The amendment revises the graph "Normalized Axial Dependence Factor for F_Q verses Elevation," Figure 3.10-3 of the Technical Specifications, by increasing the 12-foot intercept from 0.431 to 0.647.

H. B. ROBINSON STEAM ELECTRIC PLANT, UNIT NO. 2

Amendment No.109.
License No. DPR-23

SAFETY EVALUATION BY THE OFFICE OF NUCLEAR REACTOR REGULATION
RELATED TO AMENDMENT NO. 109 TO FACILITY OPERATING LICENSE NO. DPR-23

FIGURE 3.10-3 NORMALIZED AXIAL DEPENDENCE FACTOR FOR F_q VERSUS ELEVATION
(PEAK $F_q = 2.32$)

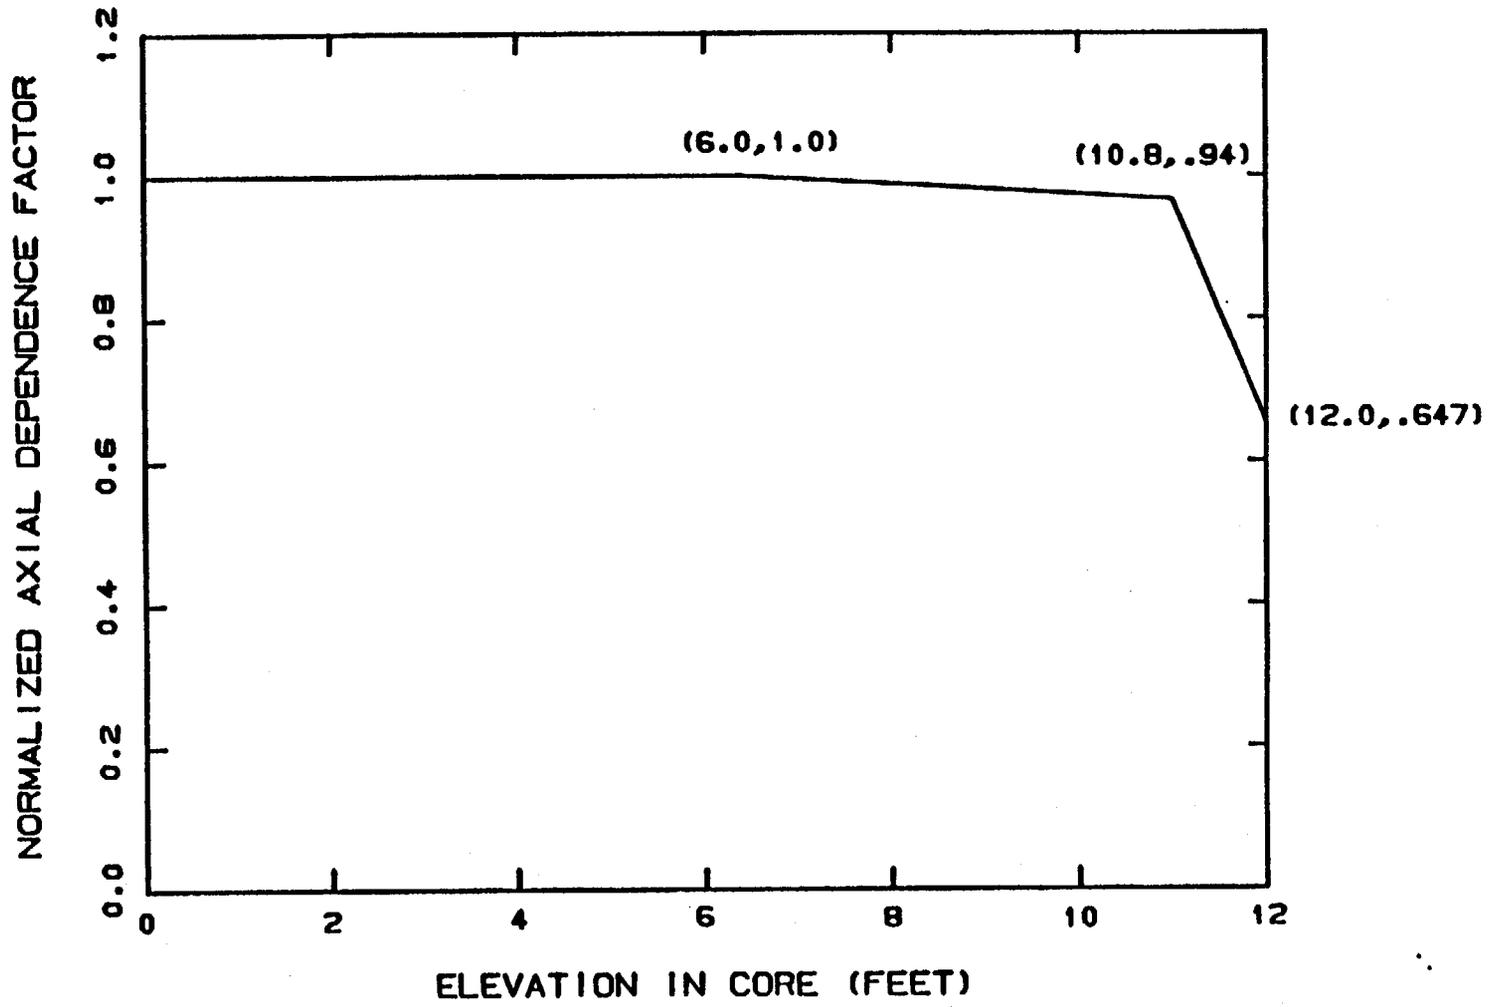
By letter to L. Rubenstein (NRC) from A. B. Cutter (CP&L) dated July 14, 1986, Carolina Power & Light (the licensee) requested a revision to the Technical Specifications for H.B. Robinson, Unit 2. The change specifically consists of a new curve of "Normalized Axial Dependence Factor for F_0 versus Elevation," $K(z)$. The revised $K(z)$ curve is a result of a reanalysis of the small break LOCA. The revised $K(z)$ curve provides substantial relief in F_0 limits toward the top of the core, since the old curve had a steeper slope from the intercept of the small break LOCA portion with the rest of the curve at the 10.8 foot axial elevation of the core. The 12 foot intercept of the new curve is 0.647, and the intercept for the old curve was 0.431.

We find the Technical Specification changes to the K(z) curve proposed in the licensee's submittal dated July 14, 1986, acceptable because: the analysis of the small break LOCA used the proposed K(z) curve as an input parameter; the analysis was performed using NRC approved models and codes; the Exxon fuel in the reactor was included in the analysis; and the results show considerable margin to the acceptance criteria limits of 10 CFR 50.46.
